To: Honorable Mayor Patrick Collins and Members of the City Council
From: Sophia Maes, Planner I
Subject: PUDC-24-6 | Centennial Heritage, 3rd Filing | Final Plat
Date: May 13, 2024

CITY OF CHEYENNE PLANNING COMMISSION
MAY 6, 2024
STAFF REPORT

FILE: PUDC-24-6: Centennial Heritage, 3rd Filing (Expedited Review)

REQUEST: Replat all of Lots 1 thru 7, Block 1, Centennial Heritage, 2nd Filing and a portion of Lot 1, Block 3, Centennial Heritage, 1st Filing.

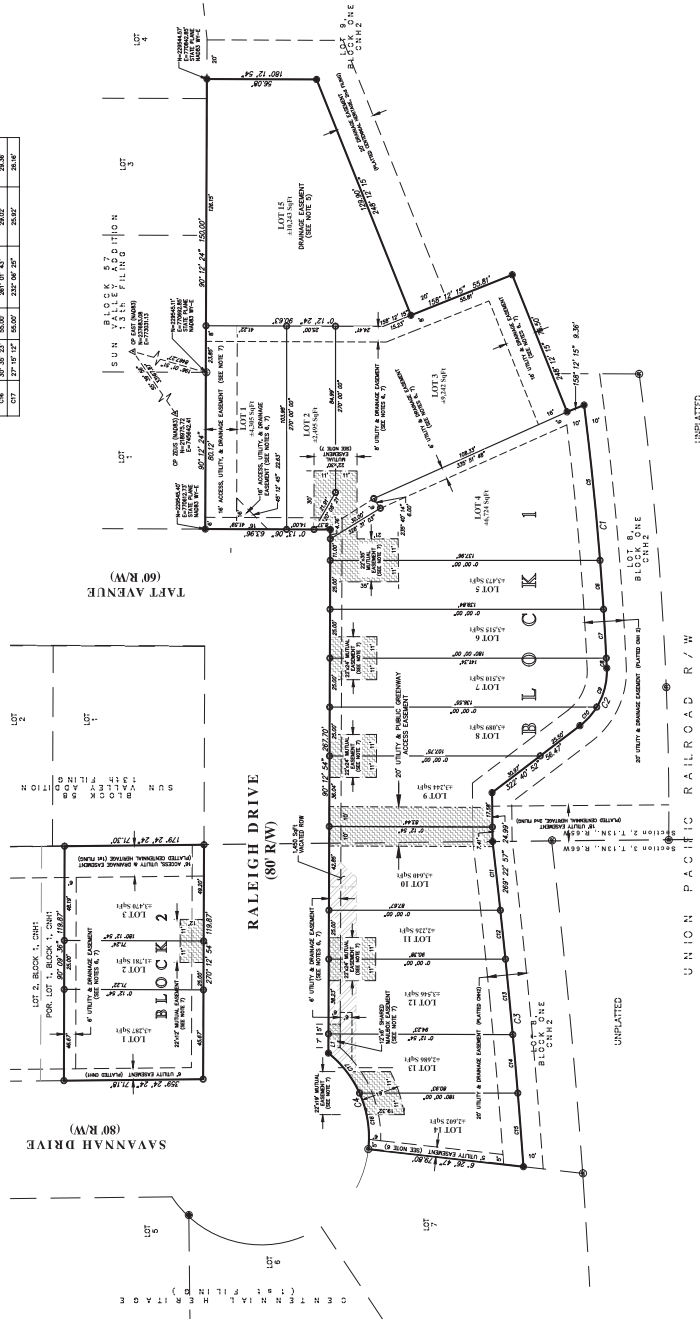
The applicant will need to provide an alley for rear-loading townhomes or provide a subdivision standards waiver. The plat proposes front access for townhome (AD1) lots, which is prohibited by UDC 4.3.6.c. The applicant has submitted a subdivision standards waiver to request relief.

This plat does appear to be able to provide all required utilities to the lots within this development. However, the preliminary plat shows water services set between sanitary services, which could present future undesired maintenance access issues (at the corner of Raleigh Drive and Taft Avenue). Water services will also need to be discussed for civil plans. These issues will be coordinated and resolved with construction.

The submitted plat does not show an 'escape' easement for Black Hills Energy to make its system 'whole' as the development is built (for which an 8-foot-wide easement along the west property line of Lot 8, Block 1 was requested). The applicant and Black Hills Energy need to coordinate to resolve the issue and add any required easements to the plat.

1. Delineation of an 'escape' easement of 8 feet in width along the west property line of Lot 8 Block 1 to allow Black Hills Energy to make system 'whole' again as the development is built.
2. Plat shows water services set between sanitary services, which could present future undesired maintenance access issues (at the corner of Raleigh Drive and Taft Avenue).
3. Water services will need to be discussed for civil plans.

Also in Criterion 3, the plat fails to show a delineation of an 8-foot 'escape' easement for Black Hills Energy along Lot 8 Block 1.

1. The following exception to be granted: Exception to Block size
2. Acknowledgement of relief: Access to a street for lots less than 36' wide (Subdivision Standards Waiver)
3. Prior to City Council approval: Resolve the issue with Black Hills Energy utilities and easements to the satisfaction of Black Hills Energy.
